**DSUP #2006-0025**

**DASH Bus Facility**

MASTER PLAN AMENDMENT #2008-0002  
DEV. SPECIAL USE PERMIT #2006-0025  
DASH BUS OPERATIONS AND  
MAINTENANCE FACILITY

Planning Commission Meeting  
May 6, 2008

*Figure 11: Section from Duke Street to Site*

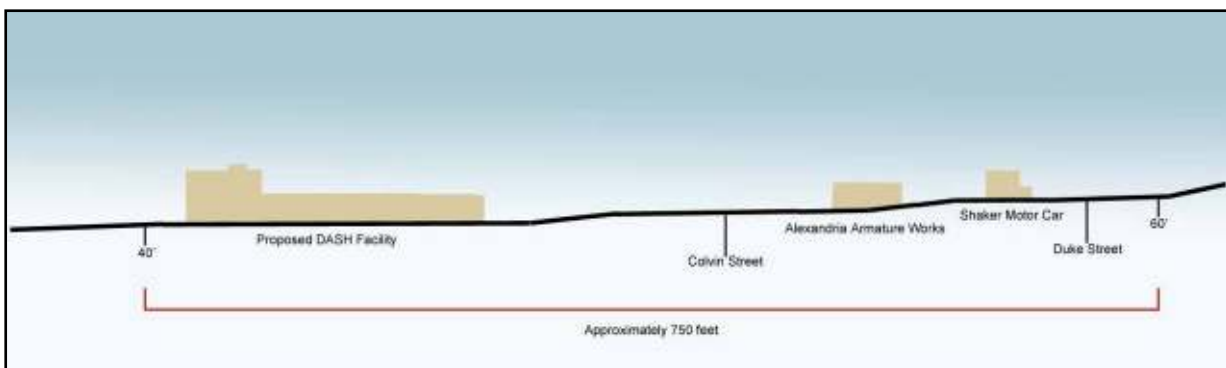
Beyond consistency with the Industrial zone and surrounding permitted building heights, staff also believes that a height of 50 feet is appropriate in this area due to the change in grade from north to south. From Duke Street, the grade drops approximately 20 feet to the railroad corridor, which forms the southern border of the site. Due to the difference in grade, the height perceived from Duke Street and the residential neighborhoods north of Duke Street will be less than 50 feet.

In addition to the transition in grade, the buildings located between Duke Street and the site offer a transition in use. The buildings located on Duke Street are primarily commercial in character and range in height from one to three stories. While the buildings located on Colvin Street also

Staff supports the request for a master plan amendment to increase building height as the change in grade from north to south, the surrounding uses, and the surrounding building heights provide a rational transition for uses and heights, and provide the appropriate context for a maximum building height of 50 feet.

*Figure 16: Proposed Fluted Columns*

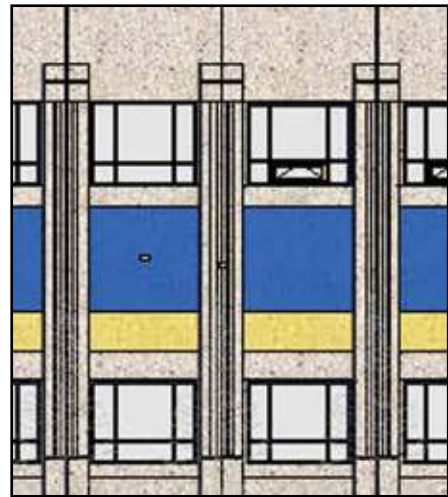
Consistent with these industrial examples, the proposed facility is characterized by art deco columns on the south and east building facades to identify the main building entrance and the administrative area. Similar to the treatment of the blue horizontal band, limiting the columns to the southern and eastern building facades expresses the location of the administrative functions and creates primary, secondary, and tertiary facades.

- g. Provide fourteen to sixteen detailed, fluted pilasters on the southern and eastern building elevations to identify the main entrance and administrative area as a primary façade.
